RE: Compliance Evaluation Inspection

Expired No Exposure Certification /terminated ALG140074
Foley Municipal Airport
510 North Airport Blvd.
Foley, AL 36536
Baldwin County (003)

Alabama Department of Environmental Management
NPDES INSPECTION REPORT

NPDES INDUSTRIAL STORMWATER INSPECTION REPORT

Northern portion of facility.

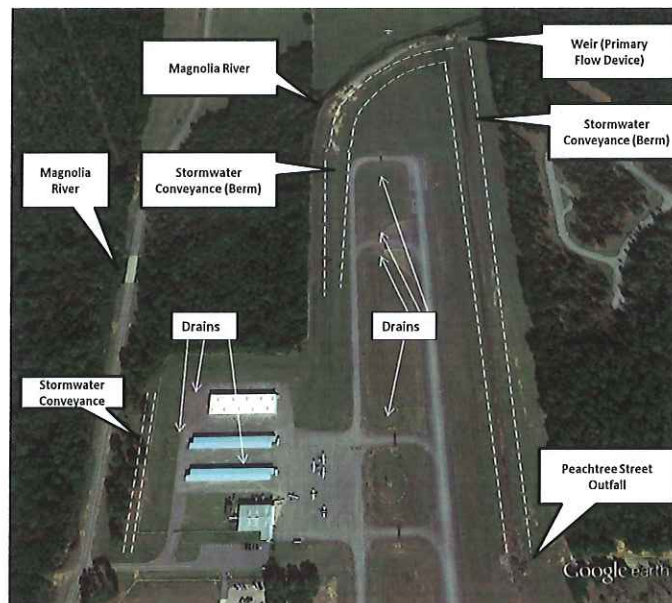
V. COMMENTS		
Comment No.		Photograph No.
1	The permit was terminated effective July 8, 2003. A No Exposure Certification was received By the Department on June 9, 2003. However, the facility has not re-certified.	
2	Recently, the facility removed an underground storage fuel tank (UST) and installed an above ground fuel storage tank. The facility has a SPCC Plan dated April 29, 2014 that covers the storage tank and fueling area.	
3	One 10,000 gallon double wall above ground aviation fuel storage tank, one 280 gallon portable aviation fuel storage tank, one 55 gallon drum bulk motor oil, and approximately two 55 gallon drums of used motor oil contained on a concrete slab.	
4	The facility has several outfalls that appear to drain to the Magnolia River. The fueling area and maintenance shop appear to discharge into a stormwater conveyance located along the northwest corner of the airport runway.

Storage buildings and parking areas appear to discharge via stormwater conveyances along the western portion of the facility and into Magnolia River.	
	Also, the Northern portion of the facility's airfield appears to drain into a stormwater conveyance via drains located between the runway and taxiway. The stormwater conveyance flows northeast along a berm to a primary flow device (rectangular weir with end contractions), just prior to discharge into the Magnolia River.	
	The southern portion of the airfield appears to discharge into a stormwater conveyance along the western portion of the facility. It should be noted that stormwater from off site appears to enter the facility's southern stormwater conveyance and discharges into the stormwater conveyance on the western portion of the facility.	
	It should also be noted that along the eastern portion of the facility, a stormwater conveyance from Peachtree Street (the "Peachtree Street Outfall"), enters a stormwater conveyance located along the northeast portion of the runway and discharges into the primary flow device prior to discharge into the Magnolia River.
